STAFF RECOMMENDATION 1712 Fifth Avenue North September 20, 2017

Metropolitan Historic Zoning Commission
Sunnyside in Sevier Park
3000 Granny White Pike
Nashville, Tennessee 37204
Telephone: (615) 862-7970
Fax: (615) 862-7974

Application: Addition and Alterations - violation
District: Salemtown Neighborhood Conservation Zoning Overlay
Council District: 19
Map and Parcel Number: 08205003400
Applicant: Saint Petka Serbian Orthodox Church
Project Lead: Melissa Sajid, melissa.sajid@nashville.gov

Description of Project: A cupola addition was constructed, windows replaced and brick cladding removed without a Preservation Permit.

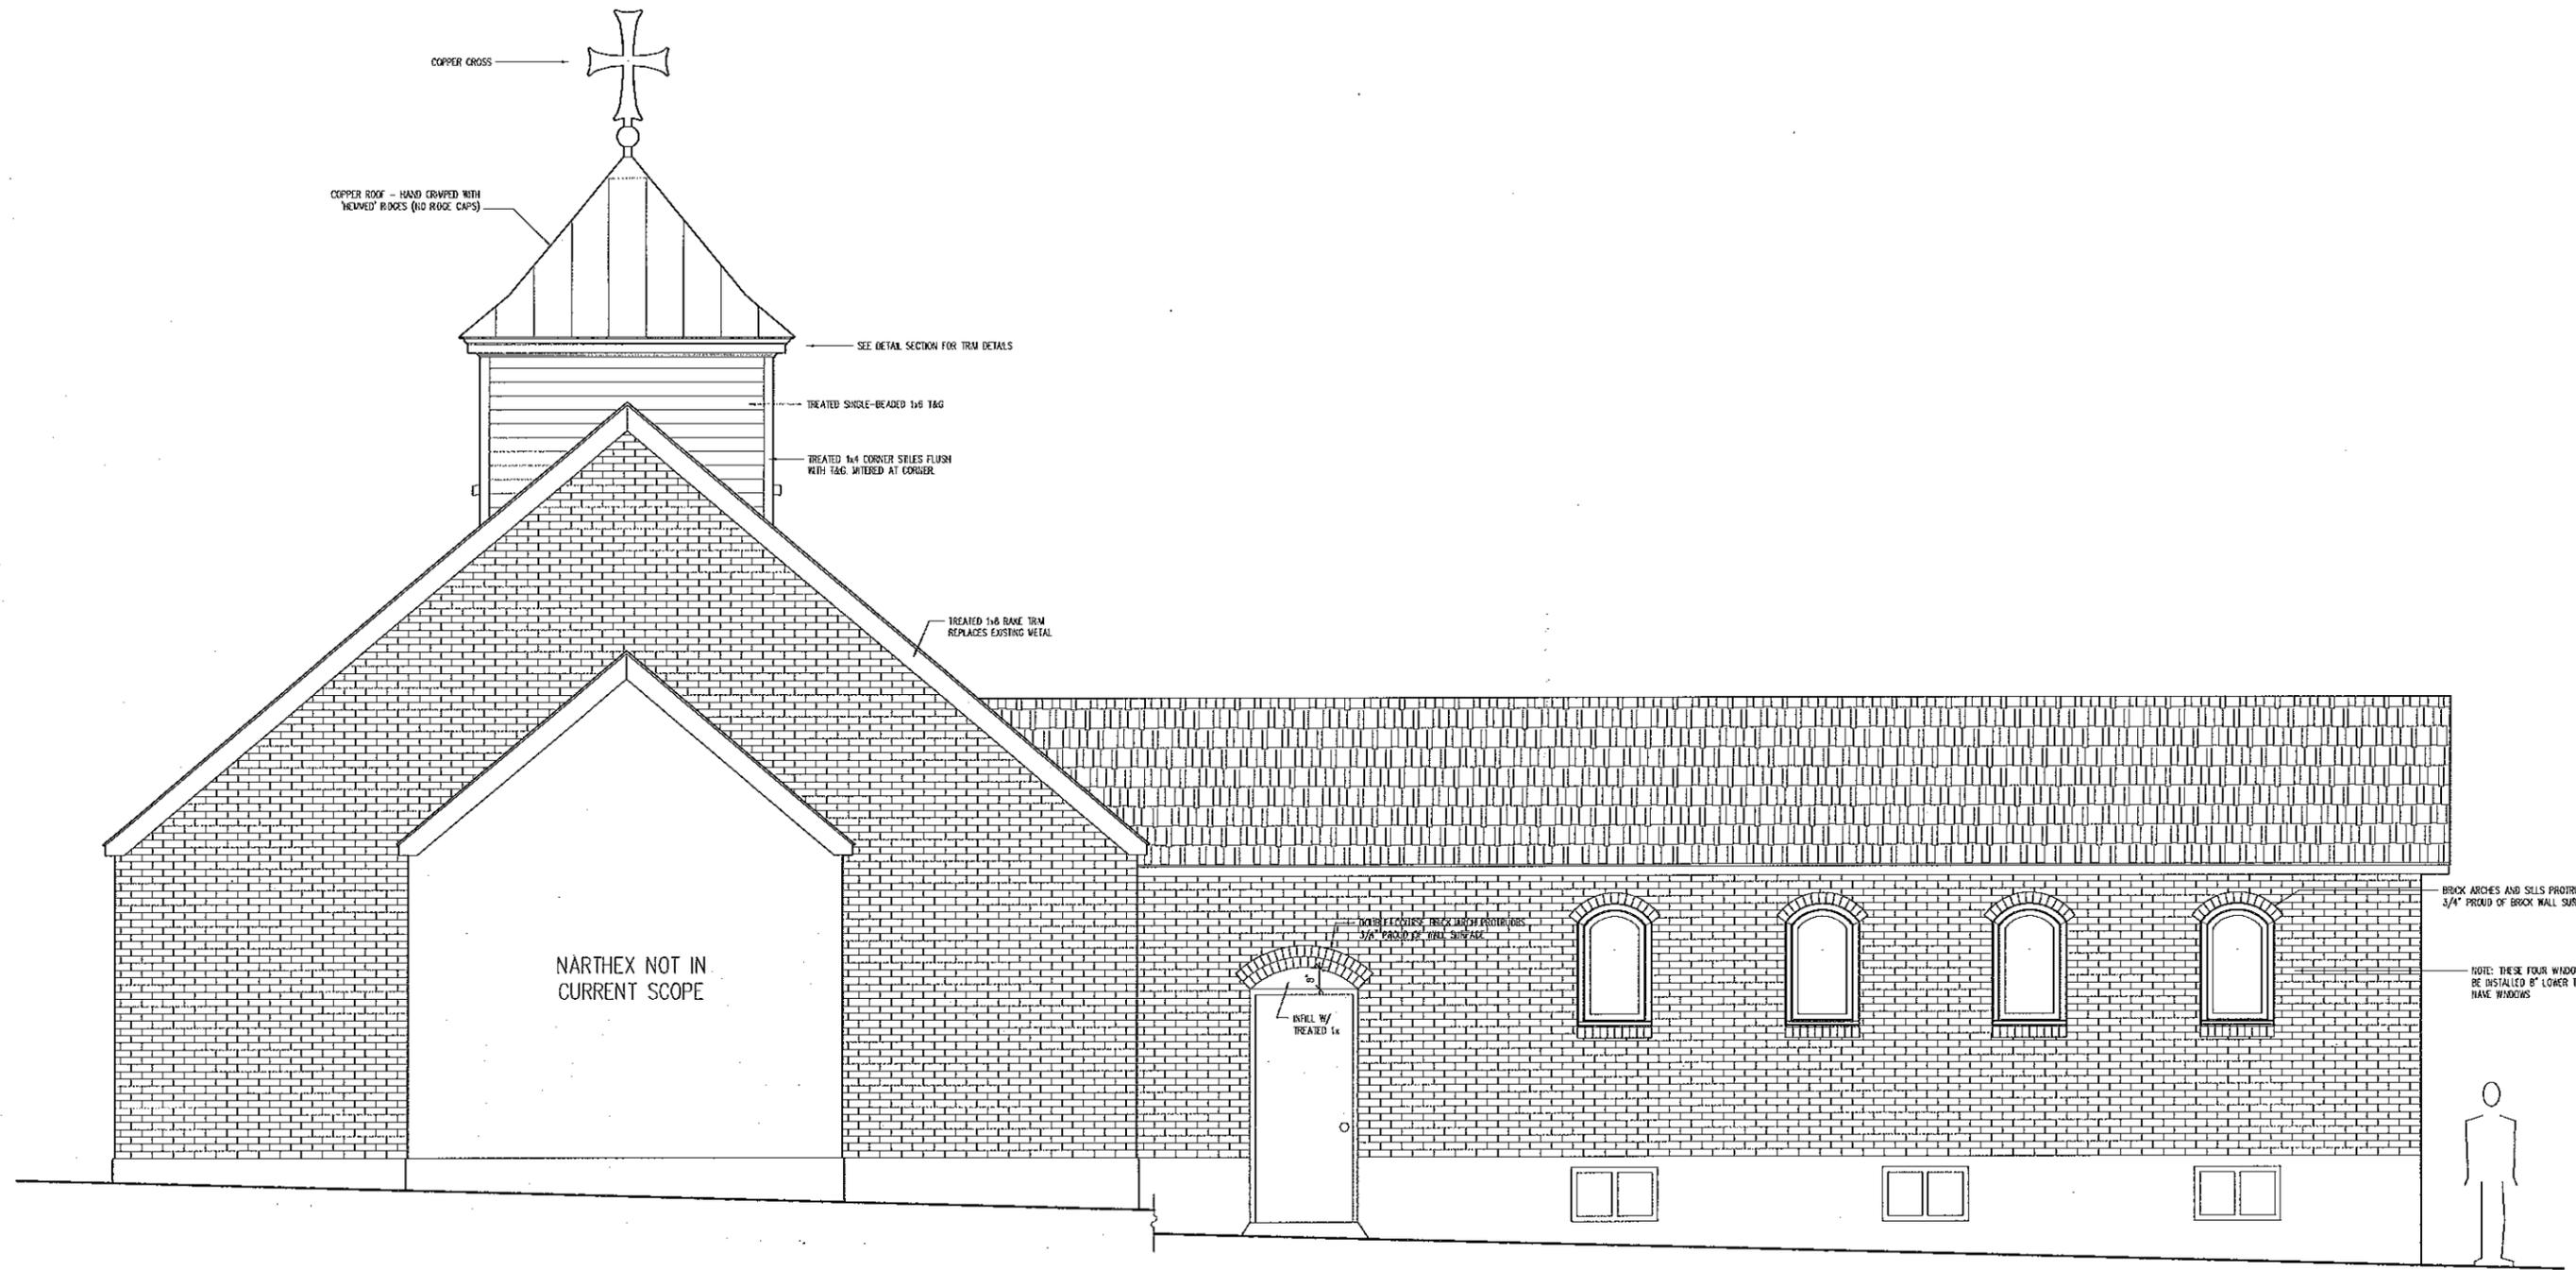
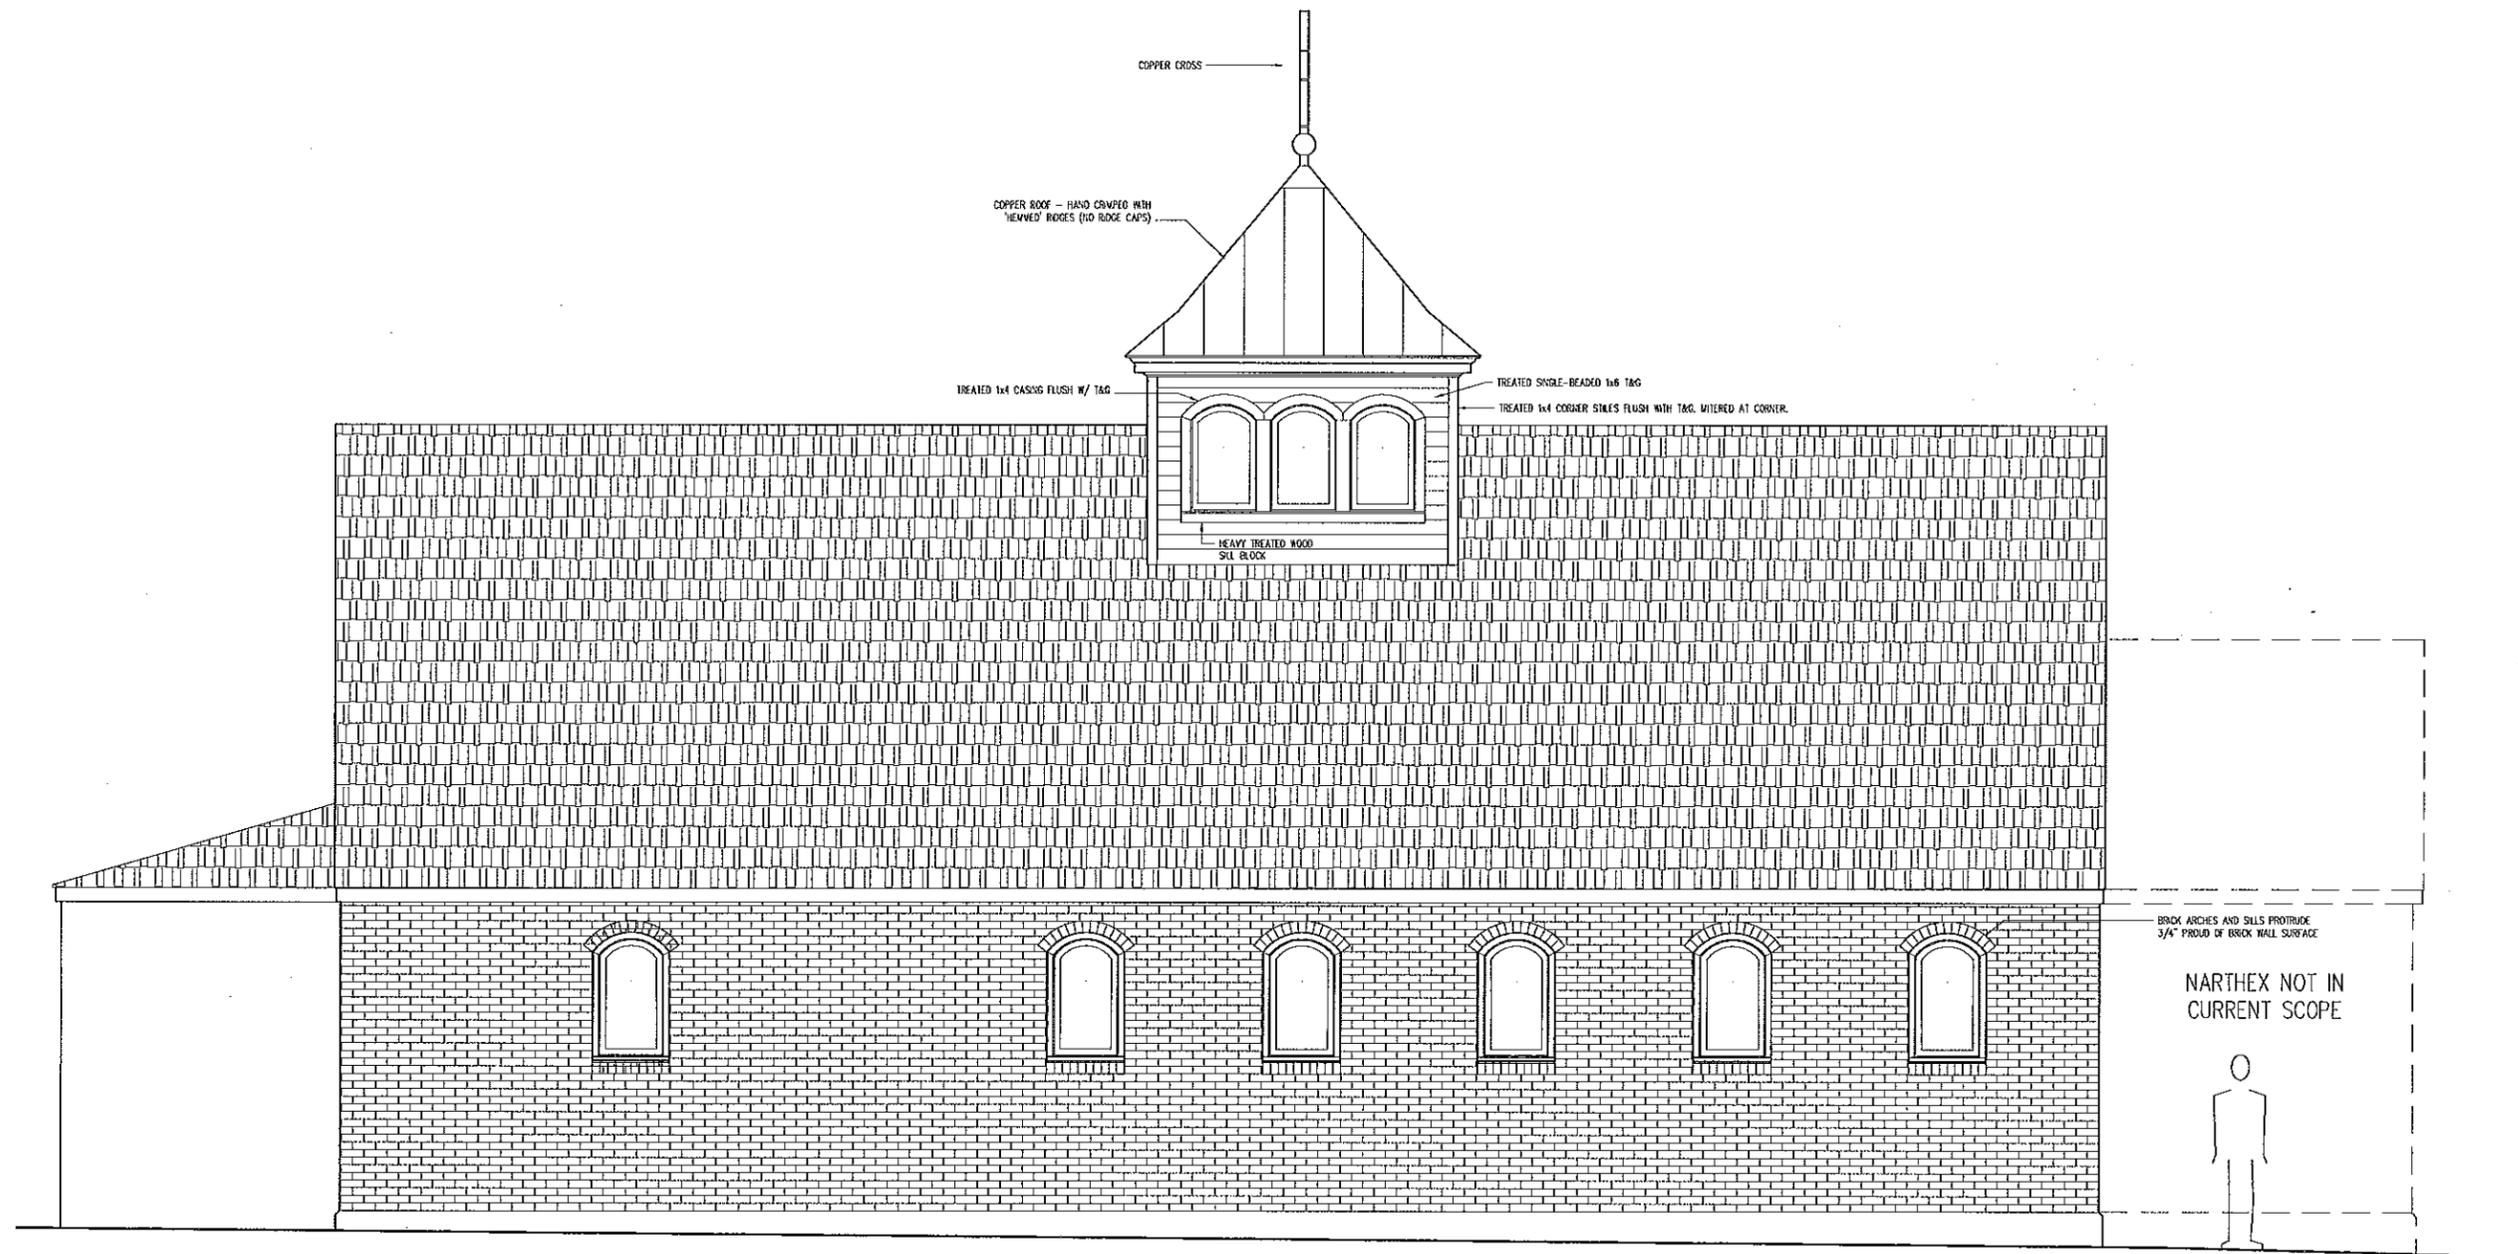
The applicant added a cupola to the primary roof of the historic church.

Location & Removability: The design guidelines call for additions to be located at the rear of buildings in a manner where it does not affect the historic form and character of the building. Cupolas are not listed as an appropriate type of rooftop addition. The Secretary of Interior’s Standards do not allow for the addition of “conjectural details.” Finding that the addition changes the historic building’s original form and design, the project does not meet section II.C. of the design guidelines for additions, II.A for location and I.B.3 of the Secretary of Interior’s Standards.

Design: Staff finds the design of the cupola to be inappropriate since it is not replicating a historic feature. The cupola contrasts greatly with the size and scale of the historic church. There is no evidence that the simple design of this historic church had a cupola. The project does not meet section II.E of the design guidelines.

All materials except for the windows meet the design guidelines. The applicant installed PlyGem 1500 Series vinyl windows, which the Commission has specifically not allowed. The project does not meet section III.D.

4. The cupola is removed and the original roof form restored to its original configuration with a roofing material to match the existing material.
5. The brick on the two sides of the historic portion of the church be altered so that the vertical stretchers that were located at the bottom of the brick wall (see figure 6) and above windows is reinstalled. No more historic brick is approved for removal.

6. The original window locations, dimensions, design and materials be reinstalled. The applicant shall submit drawings showing the original window dimensions and locations as well as information about materials for staff review, prior to making the change.
